Addendum No.: 2

Bid#: 23-52-2

Project Name: S. Military Rd US 190 & Rue Esplanade Water Main

SHEET NO.
2c - REVISED
(ADD #2)

UNDER PAVEMENT TRENCH DETAIL
(NOT TO SCALE)

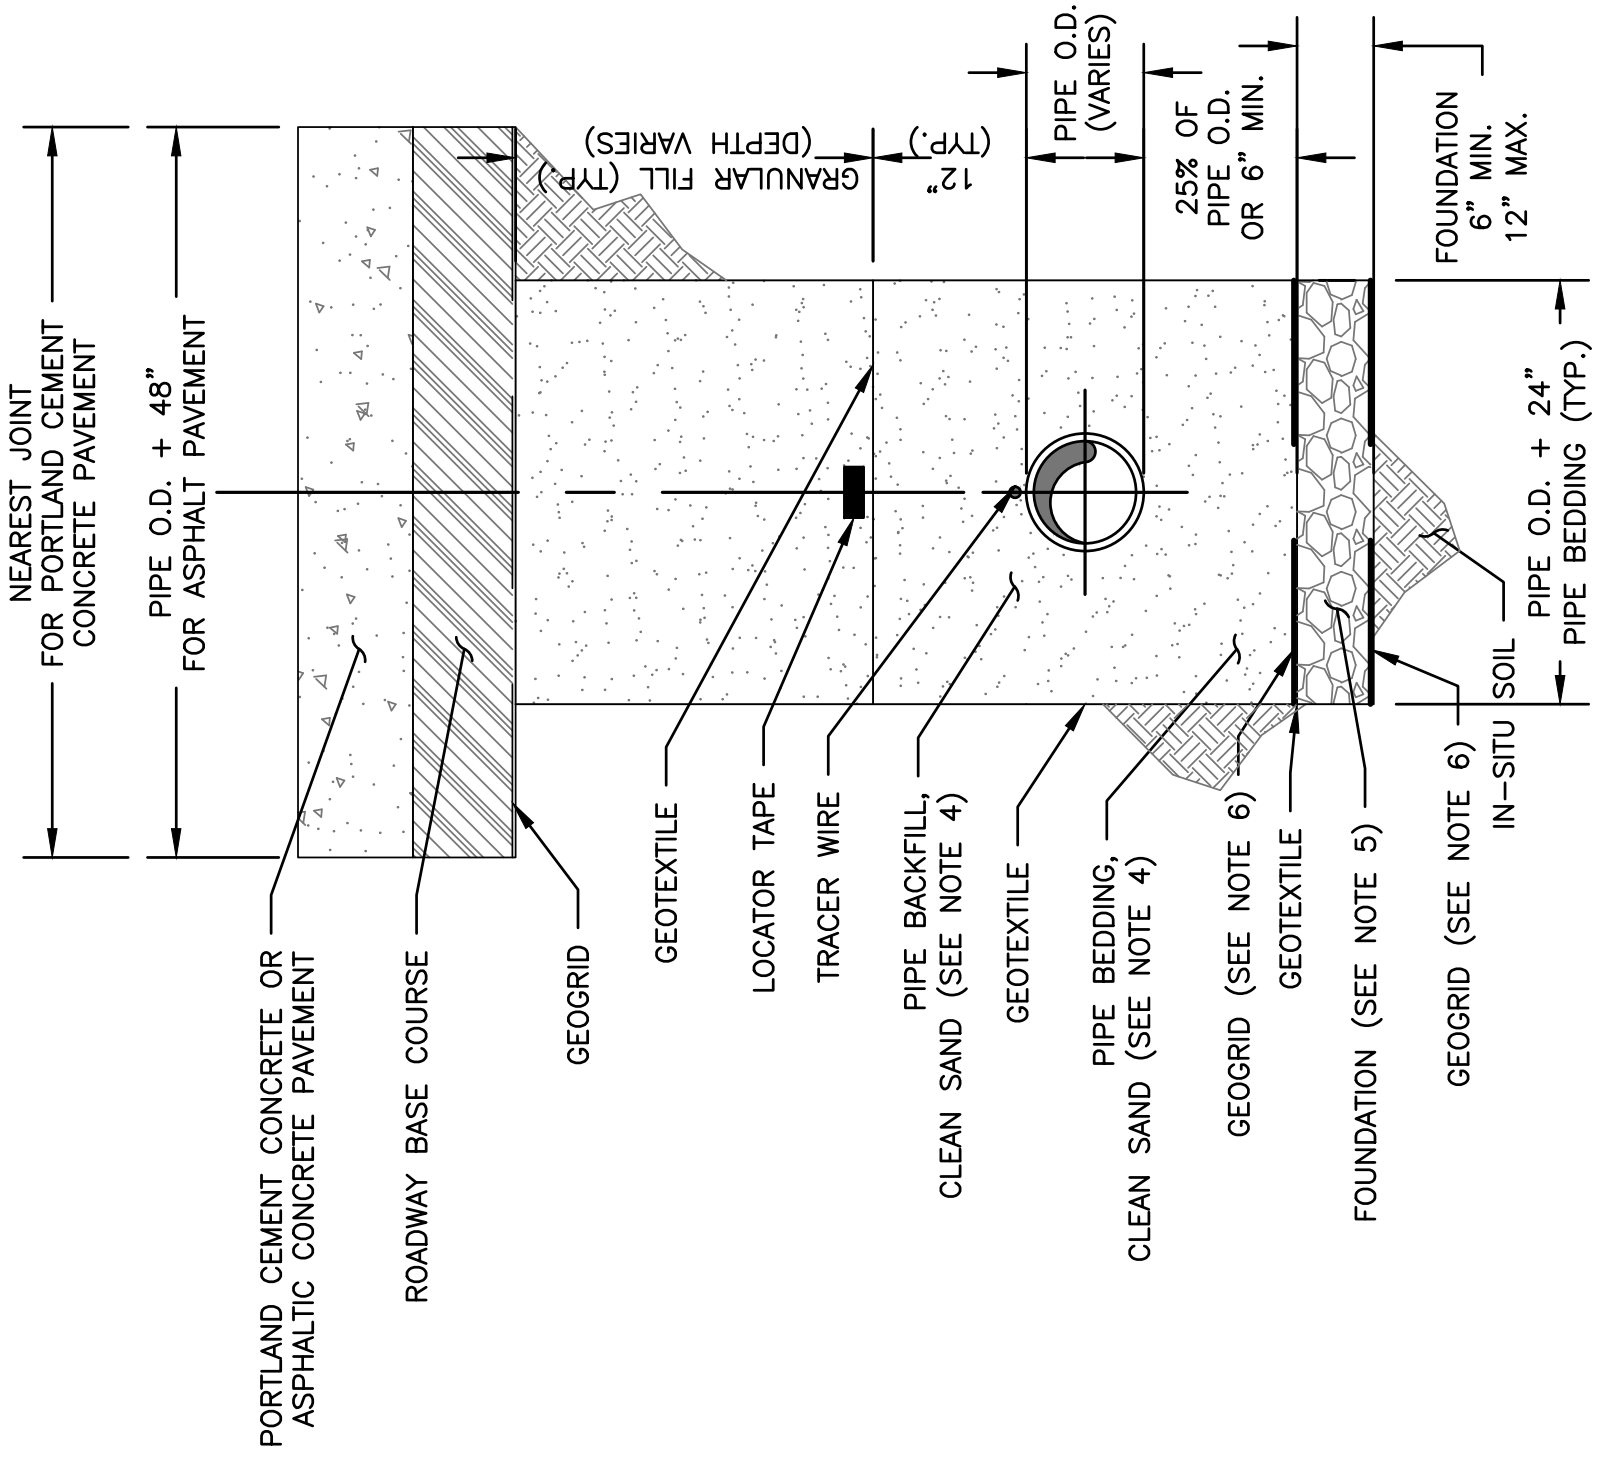
Detail and Notes for Trench Detail Outside of Pavement on Sheet 2c have been revised and provided on Sheet 2c – REVISED (ADD #2) to allow for compaction of backfill by flooding. Compaction of backfill under pavement will be by mechanical means. Details and notes for both trenching details have been revised.

- BEDDING AND BACKFILL MATERIALS FOR WATER LINES SHALL BE A CLEAN SAND COMPLYING WITH ASHTO GROUP CLASSIFICATION A-3. ALL BEDDING AND BACKFILL MATERIALS SHALL BE PLACED IN LIFTS NOT EXCEEDING A THICKNESS OF EIGHT INCHES (8") PER LIFT AND THEN COMPACTED BY MECHANICAL MEANS. SAND BEDDING AND BACKFILL MATERIALS SHALL HAVE MINIMUM COMPACTION OF 95% OF THE MAXIMUM DRY UNIT WEIGHT AS DETERMINED BY ASTM D698.

TRENCH DETAIL OUTSIDE OF PAVEMENT
(NOT TO SCALE)

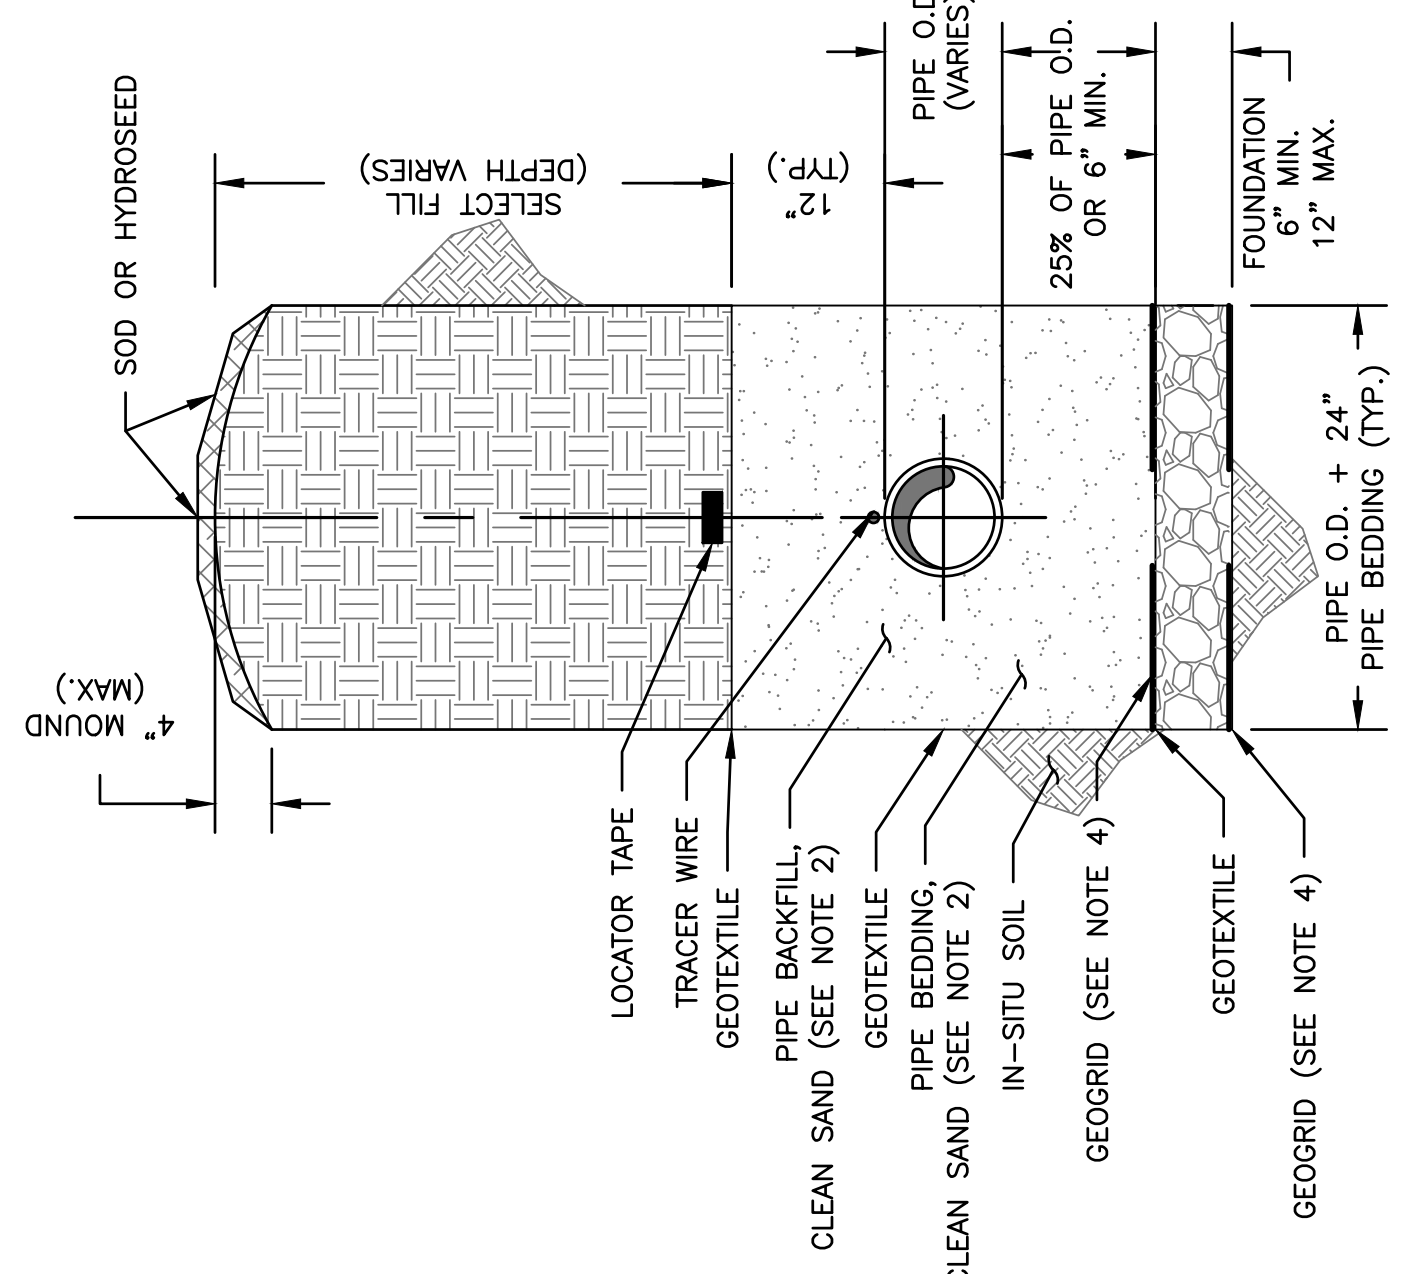
Please clarify Open Cut details concerning lifts and density testing.

- BEDDING AND BACKFILL MATERIALS FOR WATER LINES SHALL BE A CLEAN SAND COMPLYING WITH ASHTO GROUP CLASSIFICATION A-3. BEDDING AND BACKFILL MATERIAL SHALL HAVE MINIMUM COMPACTION OF 95% OF THE MAXIMUM DRY UNIT WEIGHT AS DETERMINED BY ASTM D698. SAND BACKFILL MATERIALS CAN BE COMPACTED BY FLOODING PRIOR TO TESTING. OTHERWISE, BACKFILL SHALL BE PLACED IN 8" LIFTS AND COMPACTED BY MECHANICAL MEANS TO 95% PER ASTM D698.
